PRE-IMPLEMENTATION AUDIT REPORT
FOR
PUBLIC SERVICE ELECTRIC & GAS COMPANY'S
SAFETY PARAMETER DISPLAY SYSTEM AT
SALEM NUCLEAR GENERATION STATION 1 AND 2

Science Applications International Corporation

May 5, 1986

U.S. Nuclear Regulatory Commission
Washington, D.C. 20555

Figure 2-1. SPDS Primary Display.

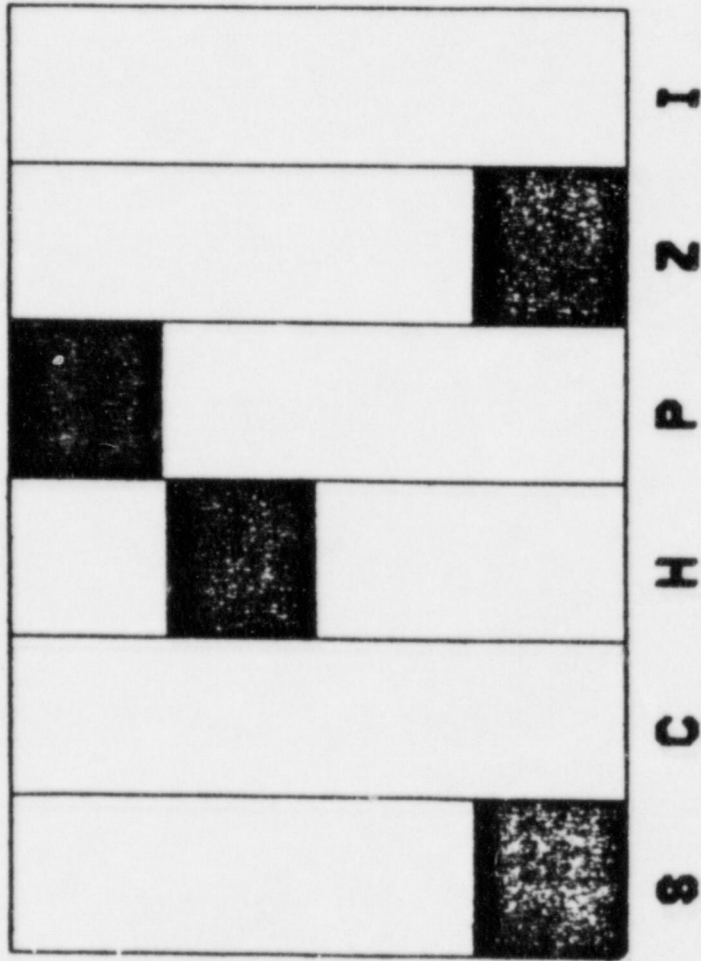
The top of each screen contained an "alarm box" which contained information about all inoperative sensors, or out-of-range values. These alarms, which are written in fairly small type, are difficult to read, add clutter to the screen, and do not seem to be necessary on every SPDS display. When asked why the alarm boxes were included (even though they were not mentioned in the system design specifications) the response was simply because "it is on all PSE&G displays." The PACE operating system makes such displays easy to implement, so it appears that little thought was given about whether or not they should be included. This type of decision may reflect the lack of a clear analysis of what the SPDS should do and exactly what information it needs to display.

Figure 2-2. Example SPDS Secondary Display.

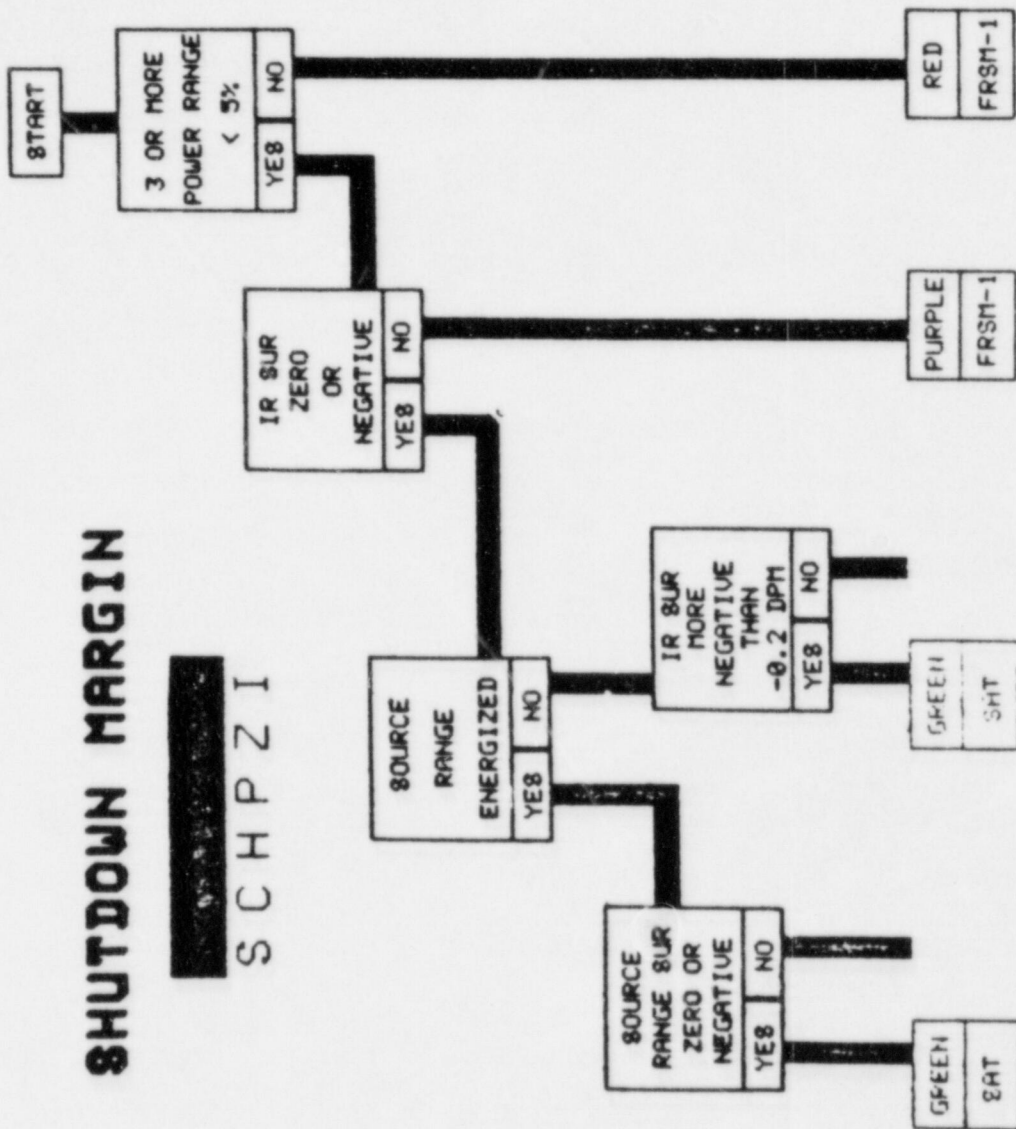
The format for the second level displays is taken directly from the Emergency Operating Procedures as developed by PSE&G from the Westinghouse EPGs. This was a "given" in the design and not a format developed through human factors analysis. The second level also contains an insert which shows the color coded bar graphs from the top level display (without the displacement in the vertical direction). This would show any changes in other critical safety functions which might occur while the STA is using a status tree second level display within a given critical safety function. The third and fourth level displays have not been finalized. However, the third level will show the parameter values and condition in a tabular format for those parameters which define the second level status tree in use. The fourth level will present trend information. PSE&G should evaluate the appropriate level to present tabular parameter information.
